AMENDMENT OF SOLICITATION/MODIFICATION OF CONTRACT			1. CONTRACT ID CODE	PAGE OF PAGES 1 4
2. AMENDMENT/MODIFICATION NO. 0003	3. EFFECTIVE DATE 26-May-2015	4. REQUISITION/PURCHASE REQ. NO.		5. PROJECT NO.(If applicable)

14. DESCRIPTION OF AMENDMENT/MODIFICATION (Organized by UCF section headings, including solicitation/contract subject matter where feasible.) N40085-15-Q-7538 PAINTING OF WAREHOUSE FLOOR, BUILDING 5B, NAVAL SUPPORT ACTIVITY (NSA), PHILADELPHIA, PA ** THIS AMENDMENT MUST BE ACKNOWLEDGED WITH YOUR QUOTE **				
Except as provided herein, all terms and conditions of the document referenced in Item 9A or 10A, as heretofore changed, remains unchanged and in full force and effect.				
15A. NAME AND TITLE OF SIGNER (Type or print)		16A. NAME AND TITLE OF CONTRACTING OFFICER (Type or print) DAVID A. RHOADS / CONTRACT SPECIALIST TEL: (215) 897-4345 EMAIL: david.rhoads@navy.mil		
15B. CONTRACTOR/OFFEROR (Signature of person authorized to sign)	15C. DATE SIGNED	16B. UNITED STATES OF AMERICA BY (Signature of Contracting Officer)	16C. DATE SIGNED 26-May-2015

RFI'S

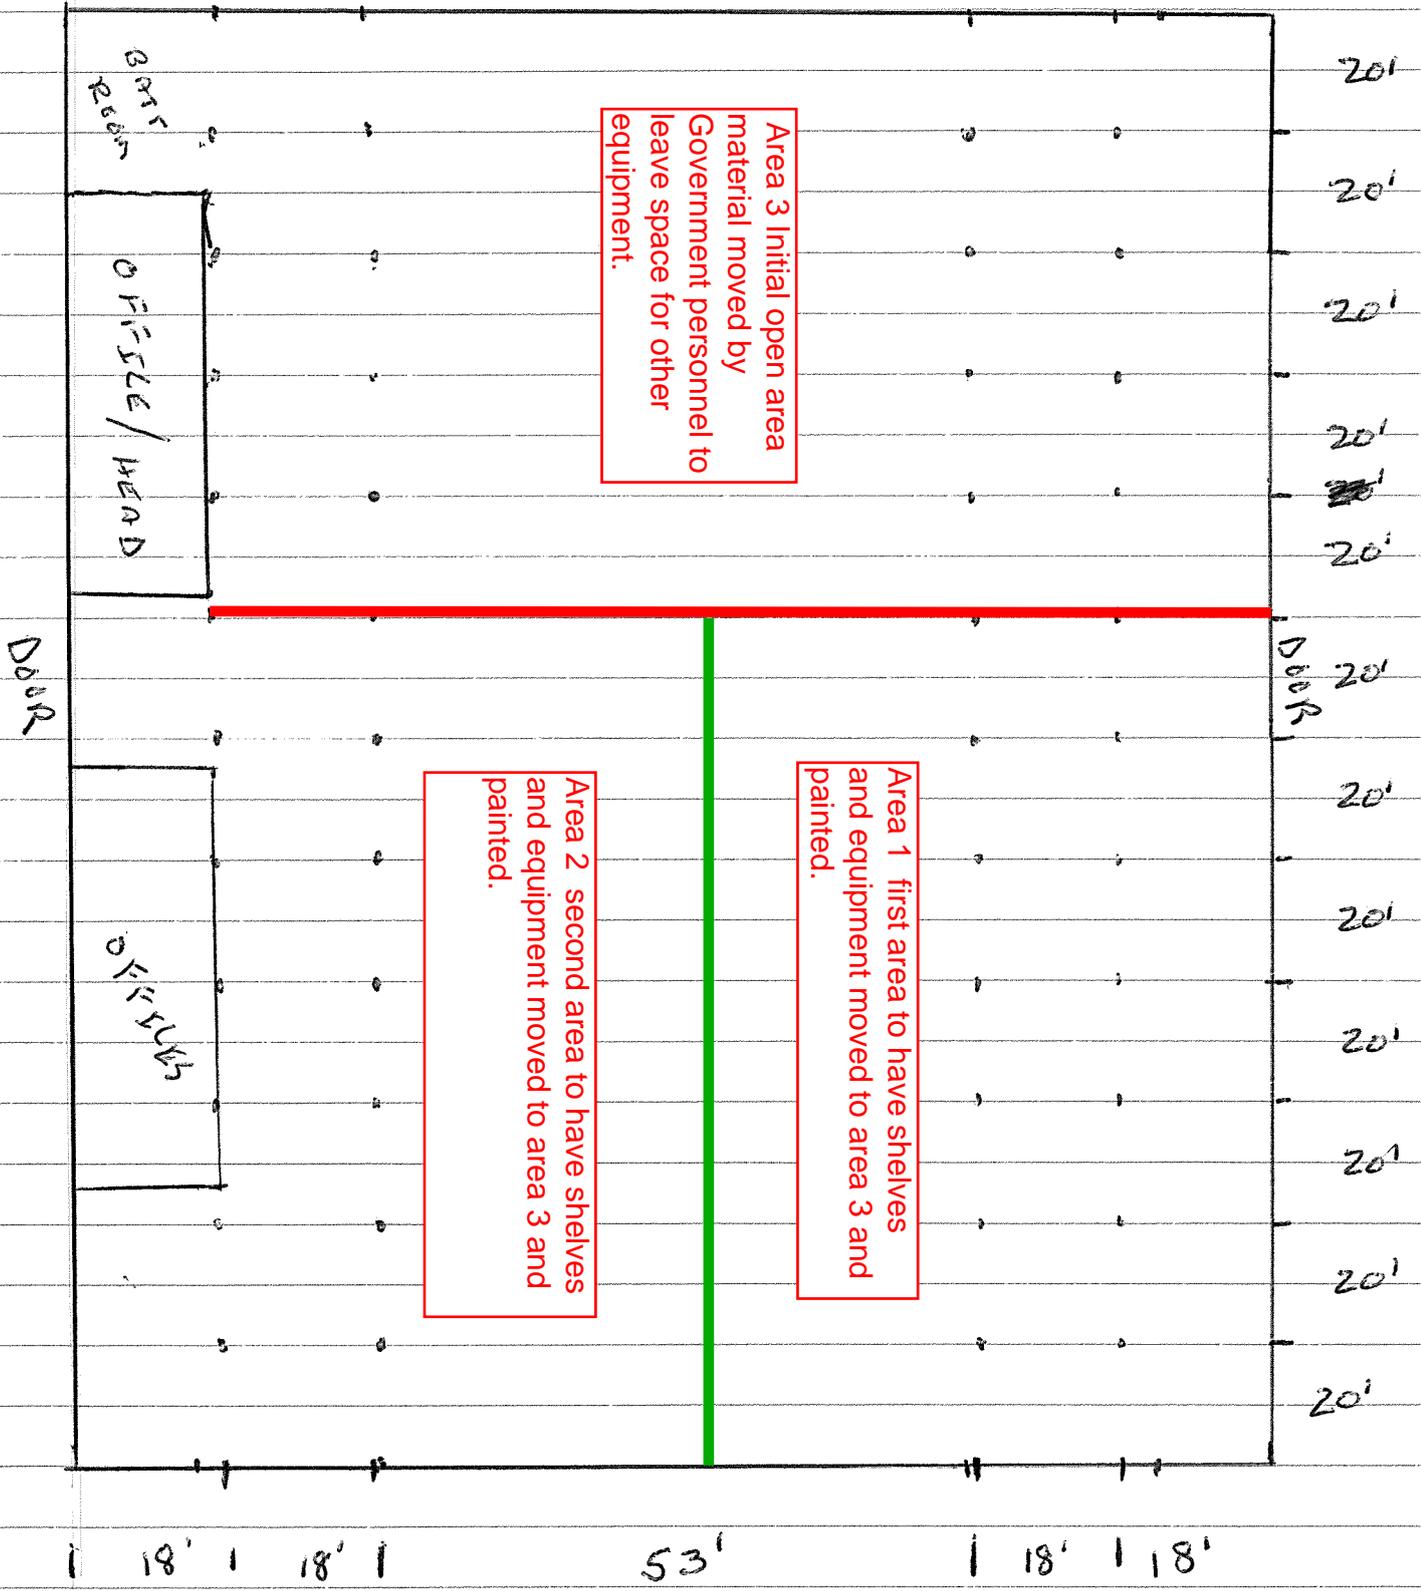
Q1. Can the work be accomplished with 2 mobilizations? For example, given that there is extensive equipment and materials located within the warehouse, can all this be moved to one side of the warehouse, complete the required epoxy floor and then after relocated all materials and equipment to the finished side, complete the remainder of the project?

Q7. Do we have to move all equipment in the building or are government employees going to?

A1. The Government will break this work out into 3 sections, with the final area being cleared and used for staging the materials from the other sections being done 1 at a time. There is limited space and a lot of material. See attached Staging Area Drawing.

A7. See answer to question 1. The Government will clear out one section of all materials. The Contractor shall then be responsible to move shelves and material from one area into this area. See Attached Drawing.

SAFETY ZONES - STRIPING LAYOUT

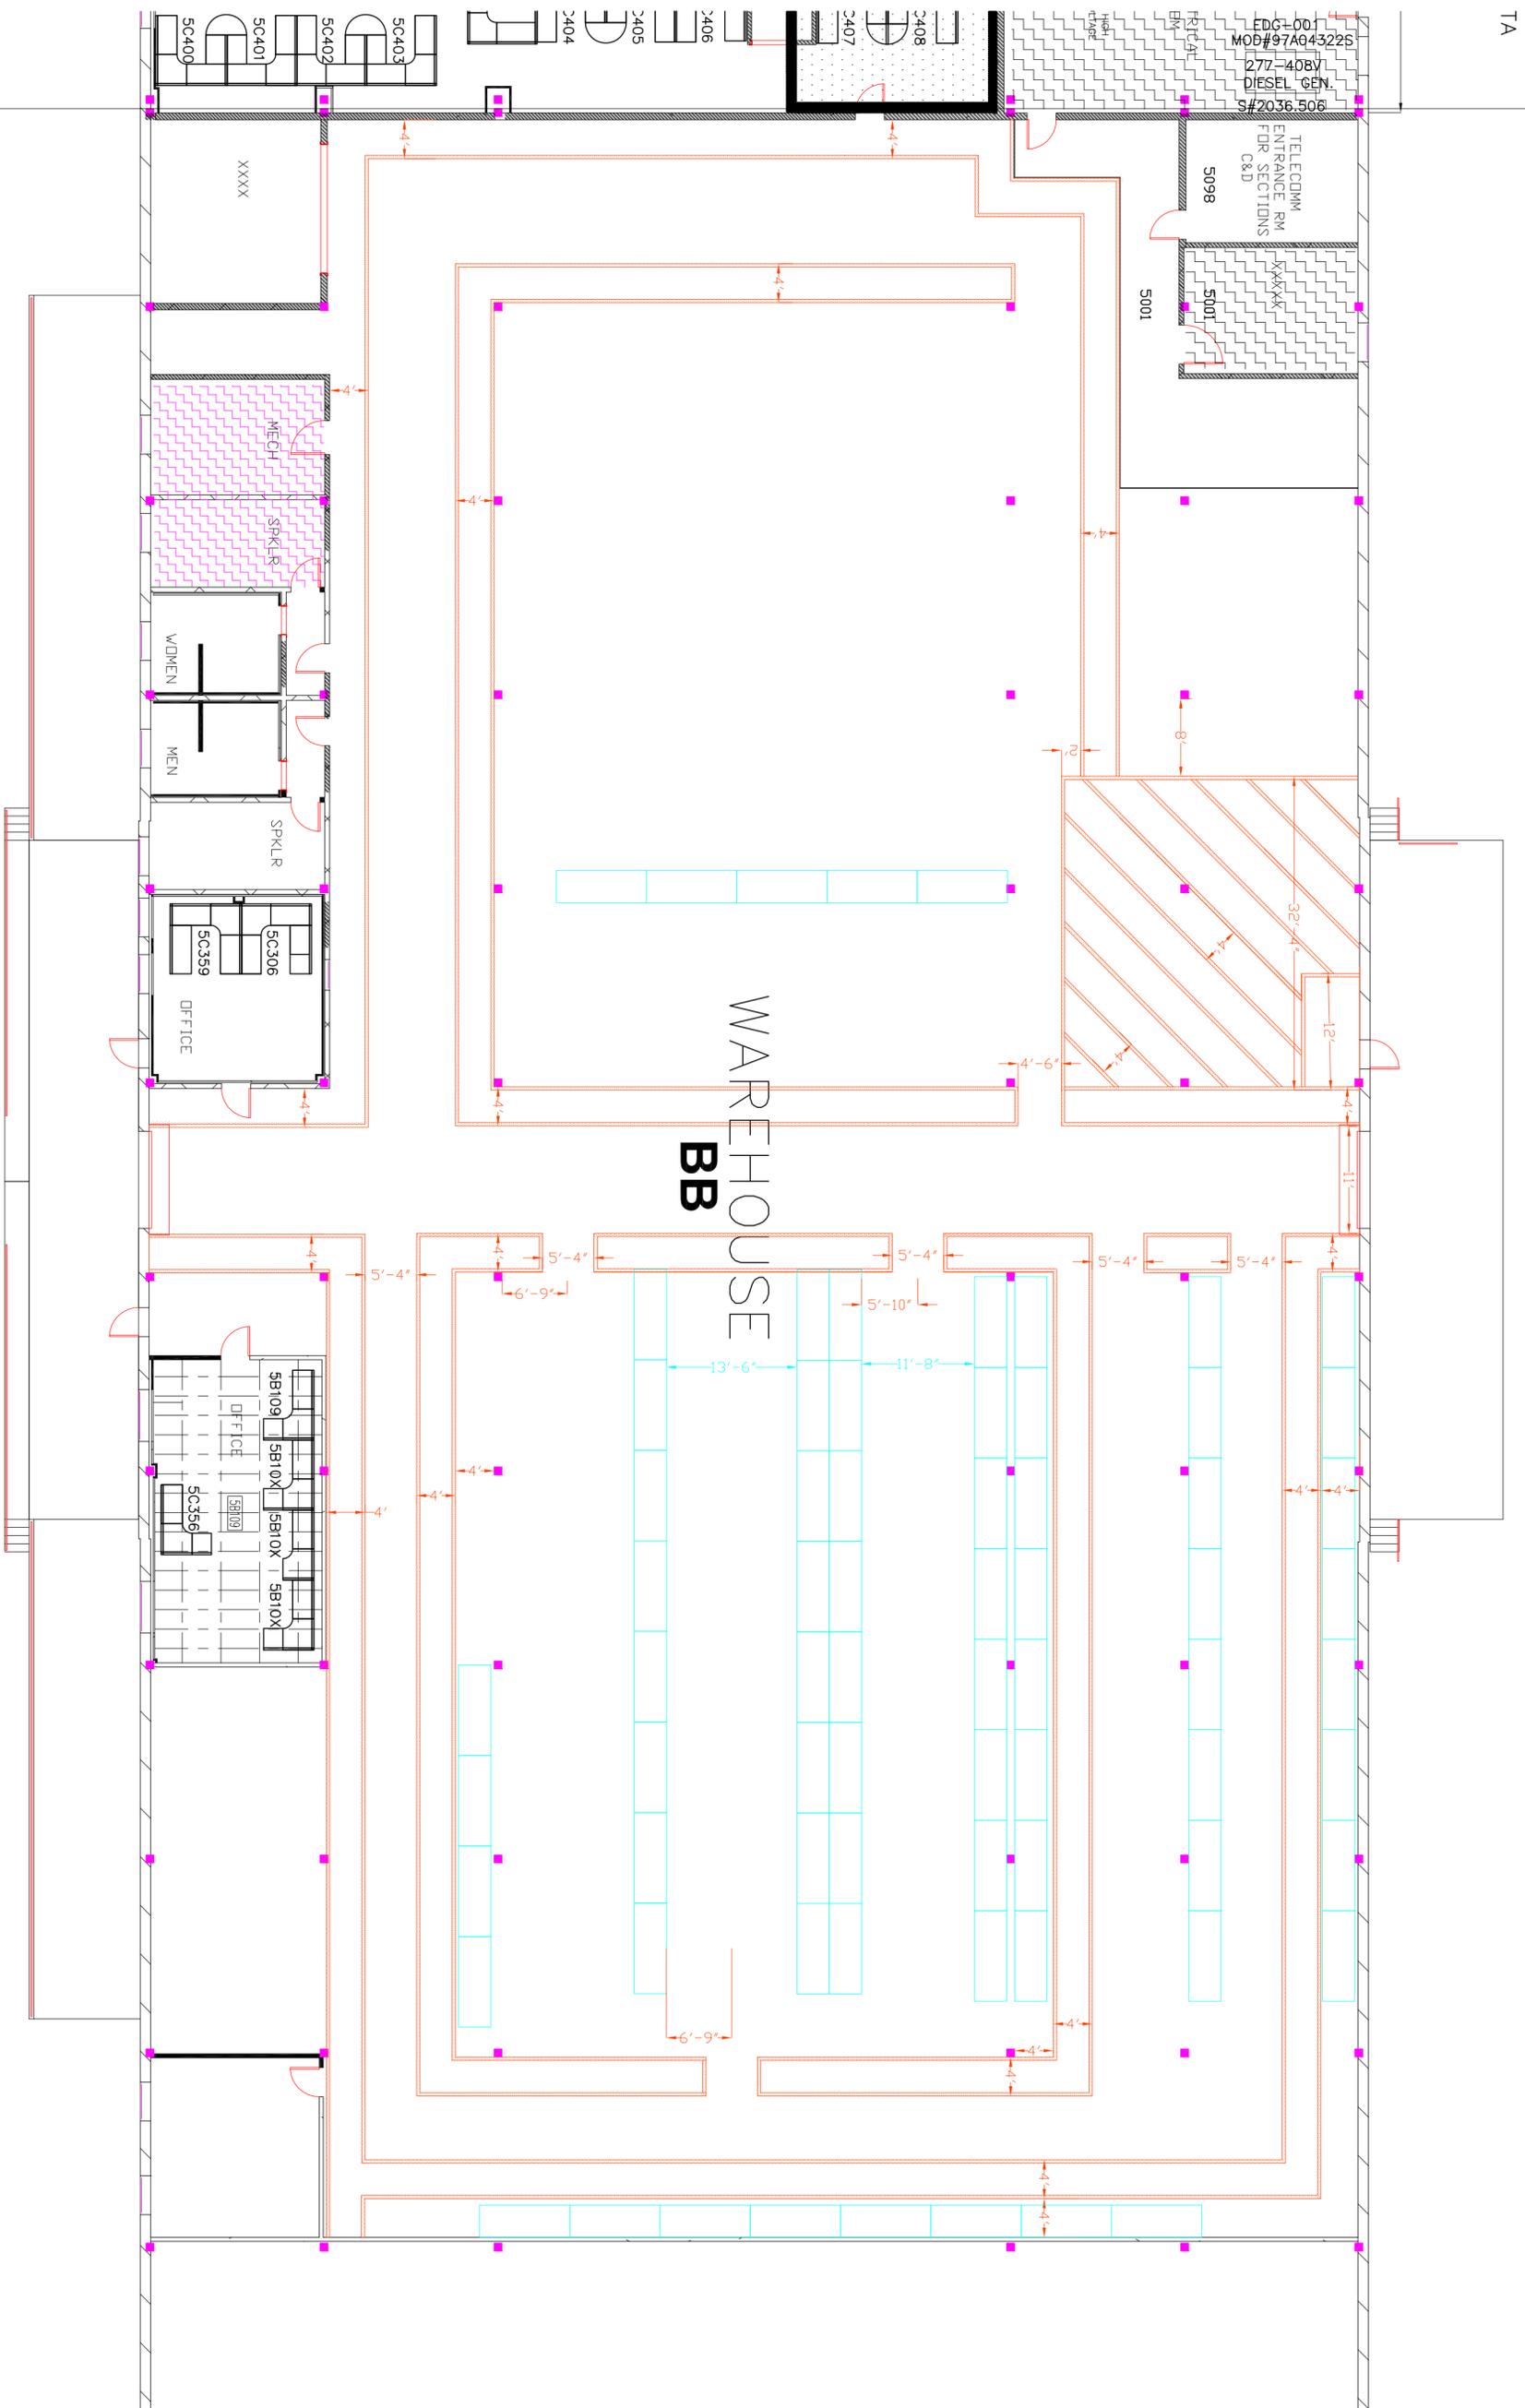
Q6. Is it going to be a solid color, ie. gray?

A6. Yes, a solid color gray. With lines provided. The Government will provide a drawing for the lines (see attached). Further clarification will be provided in additional amendment.
